THE ANNEX

APARTMENT COMMUNITY

SITE PLAN FOR PLANNING COMMISSION

Administrative Amendment Narrative

THE ANNEX
AMENDMENT FOR PLANNING COMMISSION
EXISTING CONDITIONS AND NATURAL FEATURES PLAN (SOUTH)

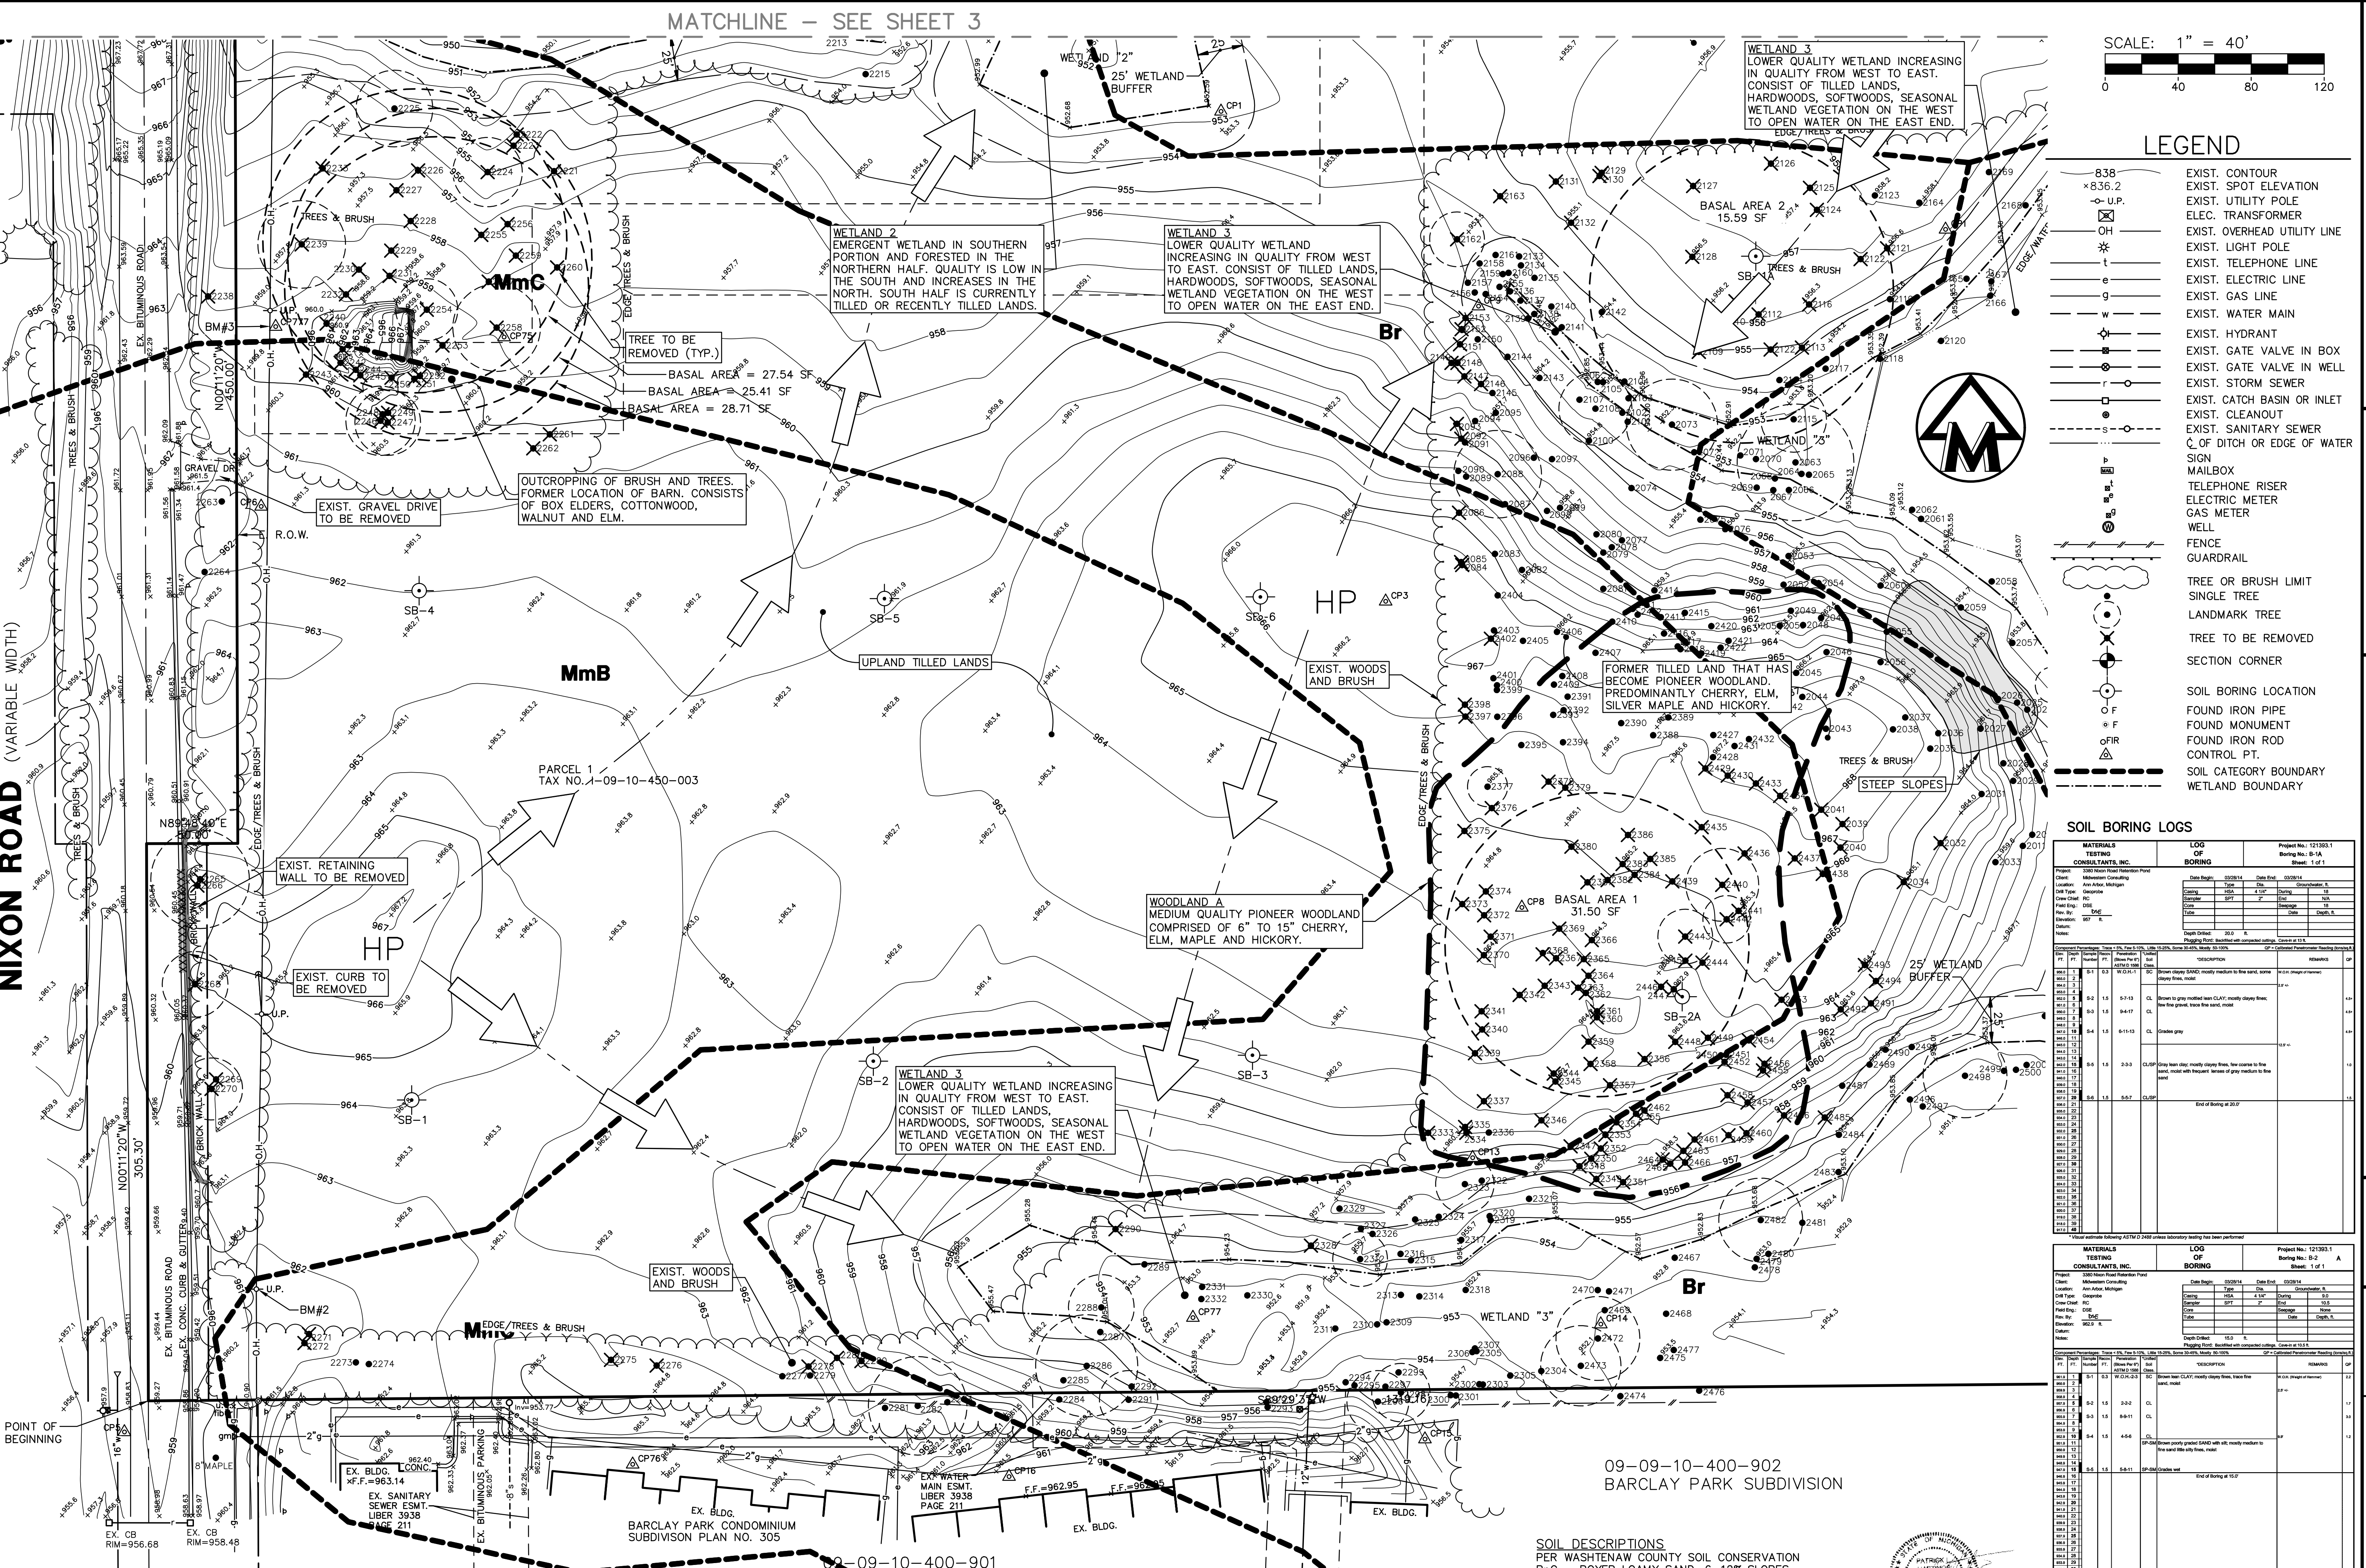
The Natural Features Protection plan has been revised. A landmark tree, tree #2270, a 17" white oak, along the Nixon Road frontage was removed during the construction process. This was done once the south entrance was placed, there was not adequate sight distance. It was removed for safety reasons. Mitigation in the form of tree replacement has been shown in this submittal at a 200% replacement, or 34" of replacement inches. This is accomplished with 14 - 2.5" caliper trees, 7 red maple and 7 red oak shown on sheets 13 and 14.

THE ANNEX
AMENDMENT FOR PLANNING COMMISSION
OVERALL SITE AND SURVEY PLAN

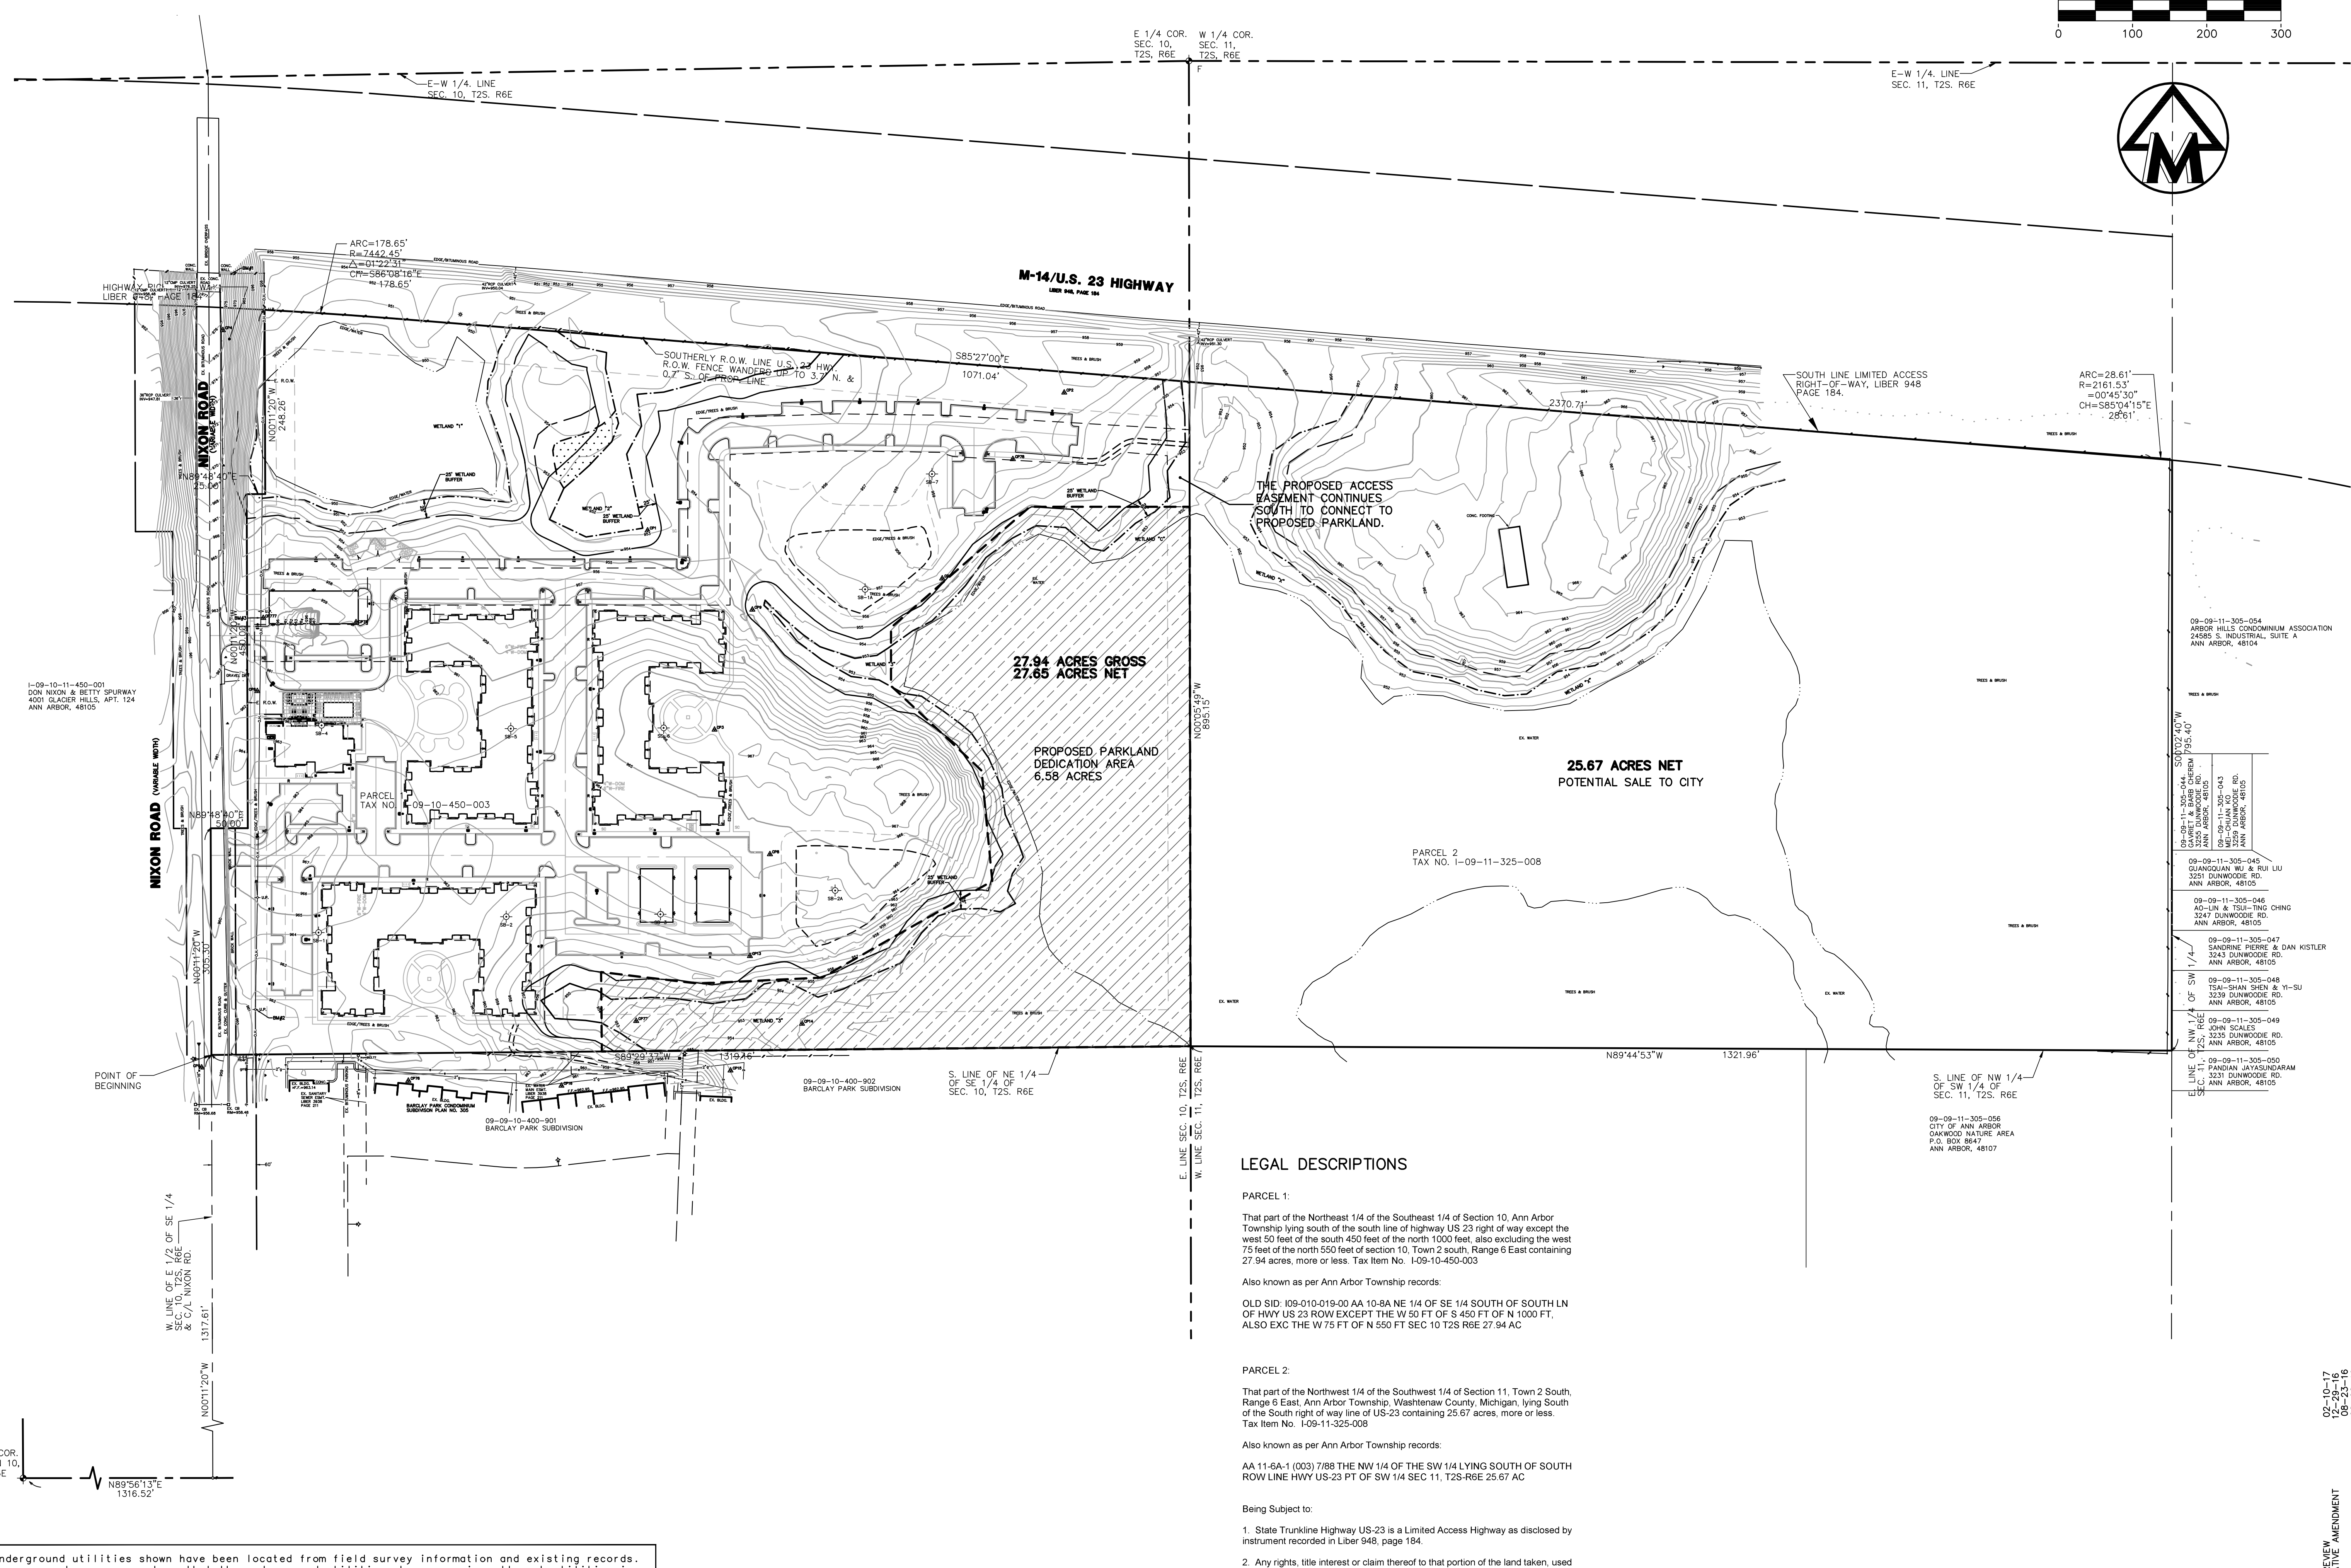
Sheet 4: The changes in the building configuration has been reflected on the overall site layout.

THE ANNEX
 AMENDMENT FOR PLANNING COMMISSION
 DIMENSIONAL SITE PLAN (SOUTH)

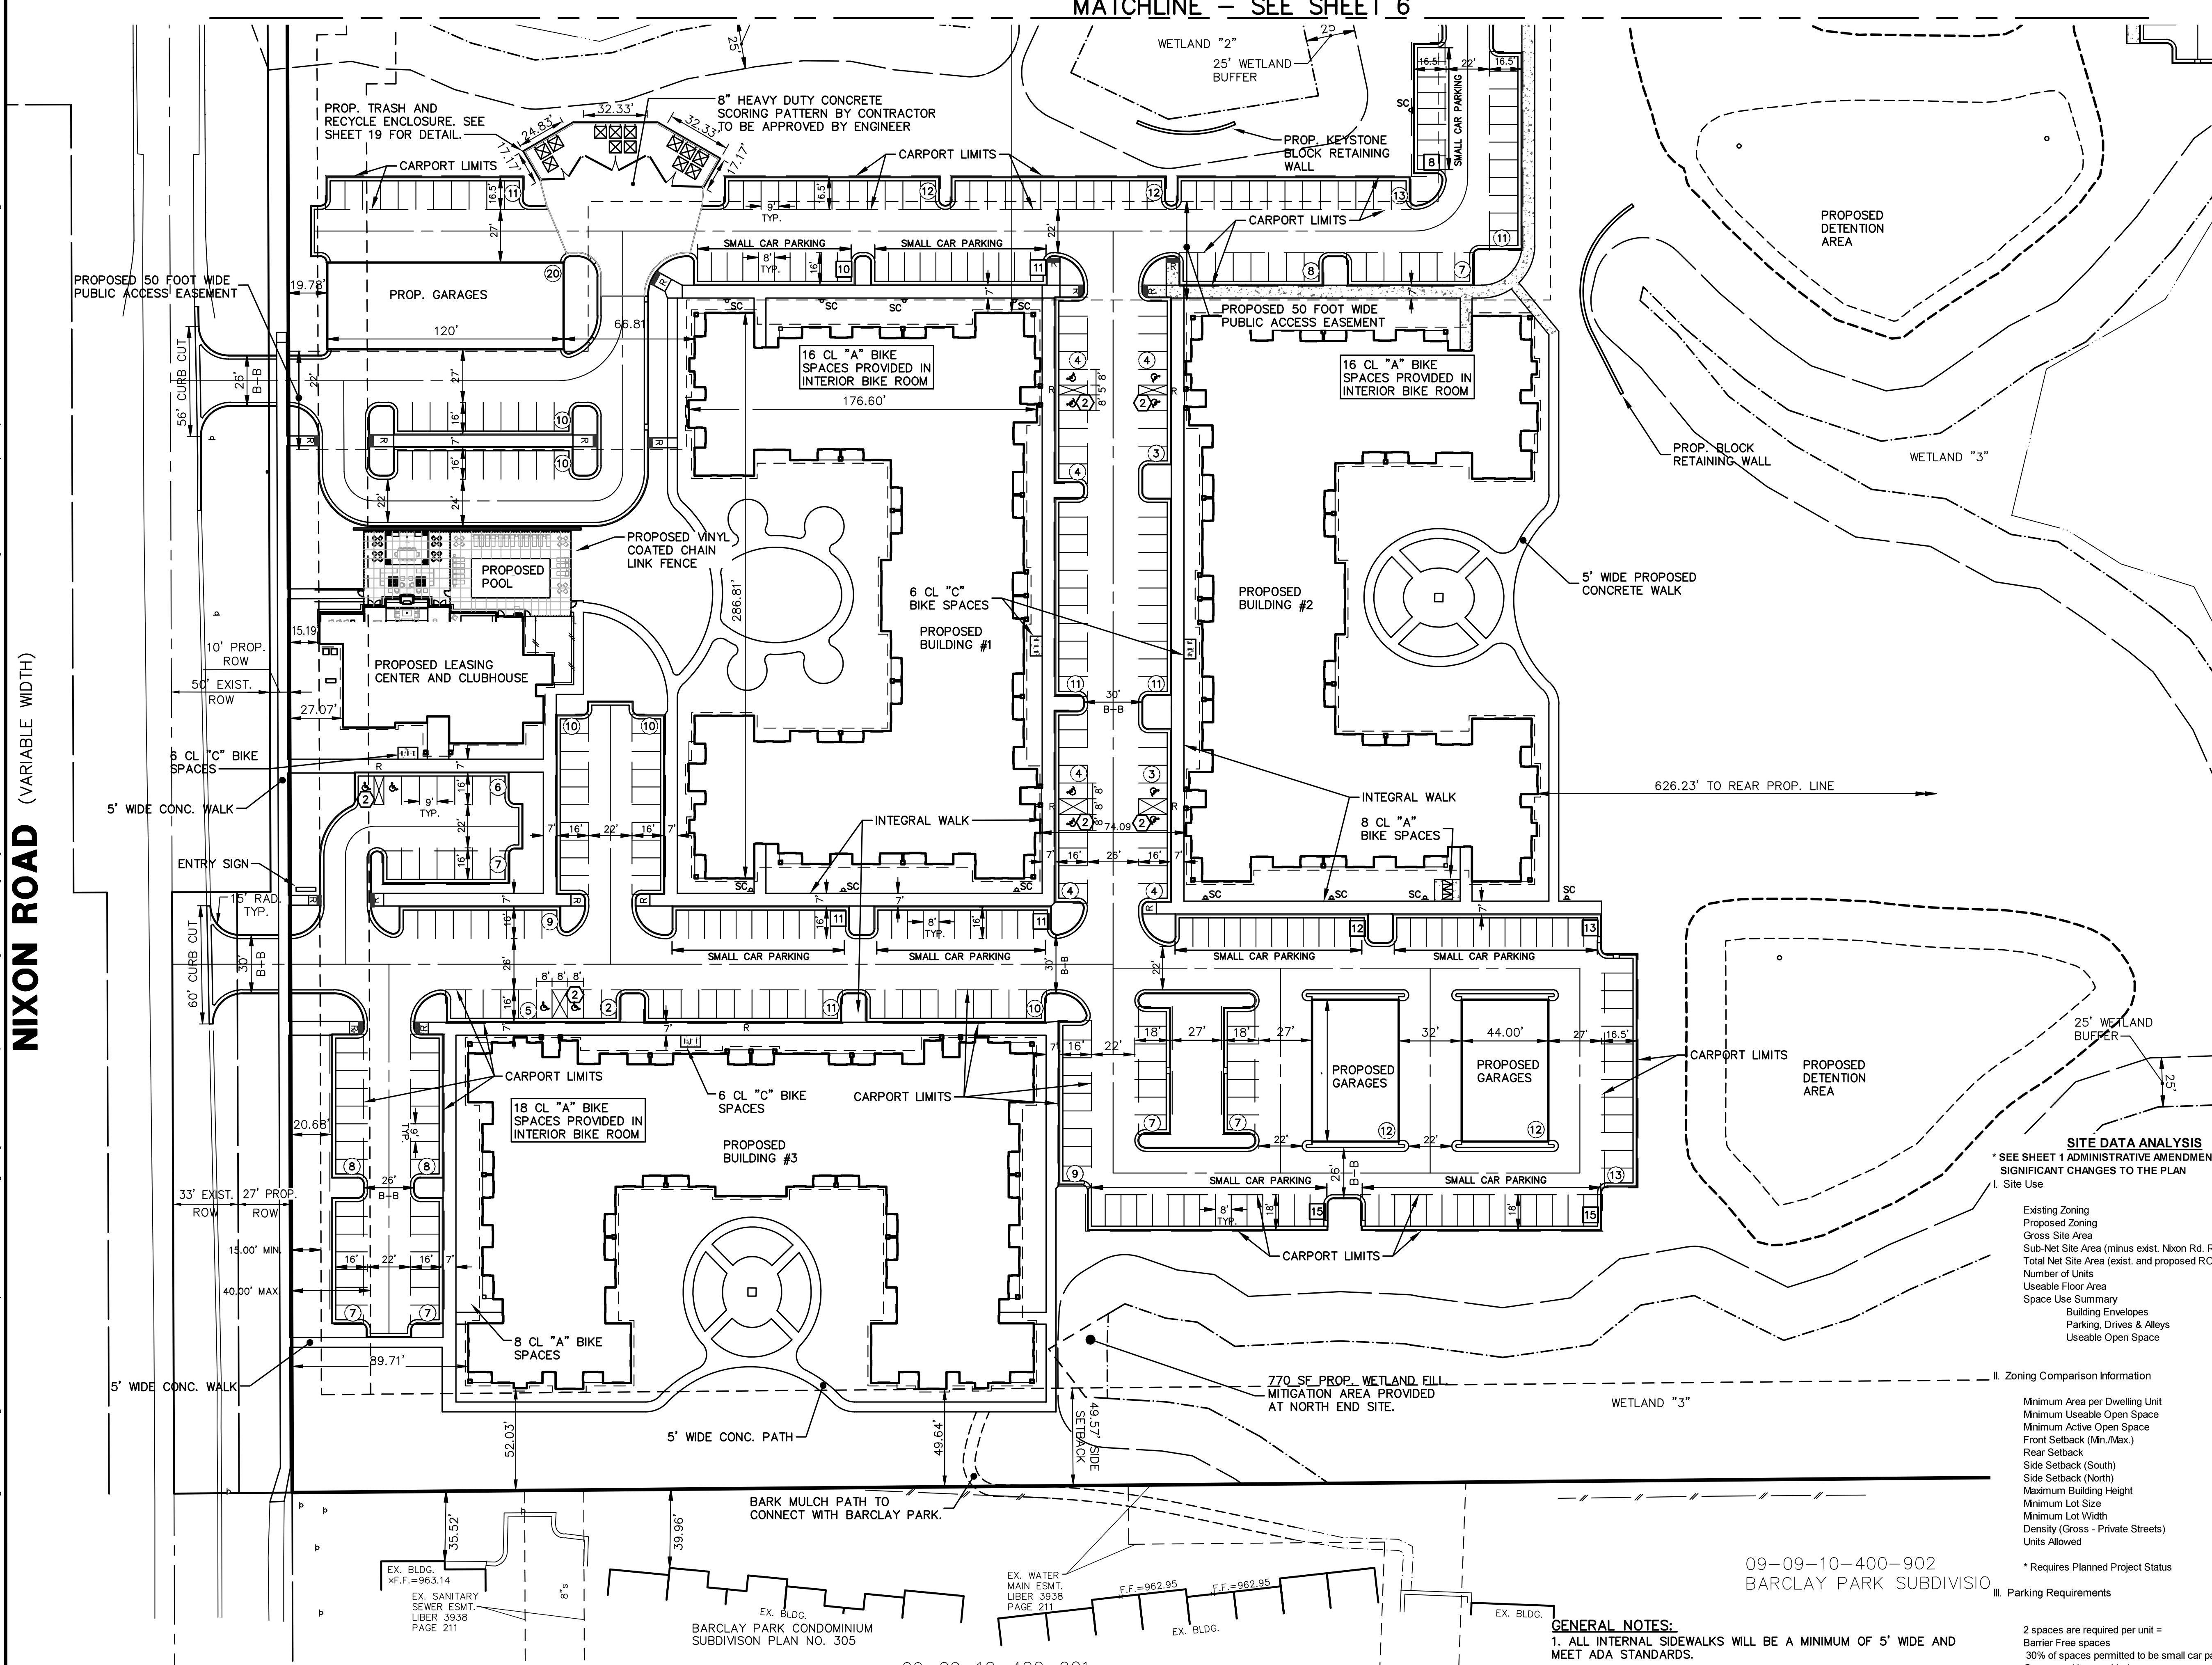
Sheets 5 & 6: The changes in the building configuration has been reflected on the overall site layout. Site dimensions have been updated as well as the site data analysis. Bike parking has been reconfigured based on the elimination of the fourth building. Sidewalk serving the buildings have been revised due to door locations on new buildings as well as barrier free parking spaces.
